**Economic and Social Council**Distr.: General  
1 August 2012

**Economic Commission for Europe****Inland Transport Committee****World Forum for Harmonization of Vehicle Regulations****158<sup>th</sup> session**

**1958 Agreement – Consideration of draft amendments  
to existing Regulations submitted by GRE****Proposal for Supplement 4 to the 01 series of amendments to  
Regulation No. 123 (Adaptive front lighting systems (AFS))****Submitted by the Working Party on Lighting and Light-Signalling\***

Example 1

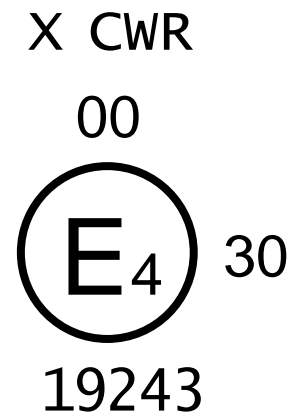
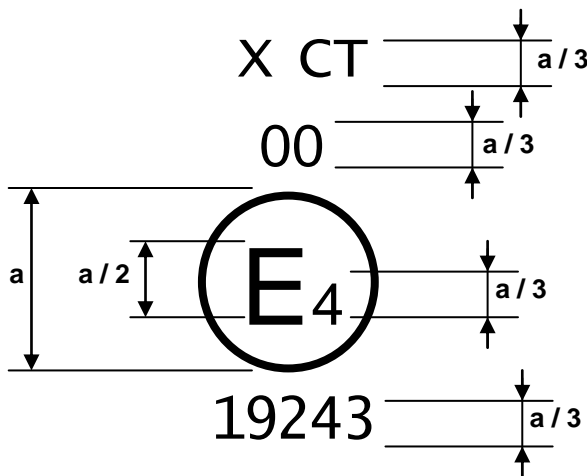
Annex 2, amend to read:

### Examples of arrangements of approval marks

$a \geq 8$  mm (on glass)  
 $a \geq 5$  mm (on plastic material)
